1988/1989 GL1500 SADDLEBAG WATER LEAKAGE

All 1988 and 1989 GL1500s

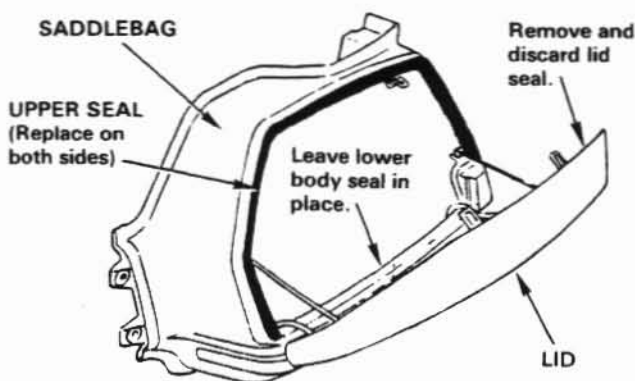
Some 1988/1989 GL1500 owners may complain about water leakage into the saddlebags while riding in the rain or washing the motorcycle.

An improved saddlebag body seal is now available. The new seal is preformed and thicker, eliminating the need for the lid seal.

1. Remove and discard the left and right upper saddlebag body seals. Leave the lower body seals in place (both sides).

2. Remove and discard both lid seals.

NOTE: The lid seal is not required with the new, thicker body seal.

4. Attach the new seals using Hondaline Weatherstrip Cement (H/C: 1724426), 3M Fast-Tack #08031, or equivalent. Follow the manufacturers directions to assure complete drying.
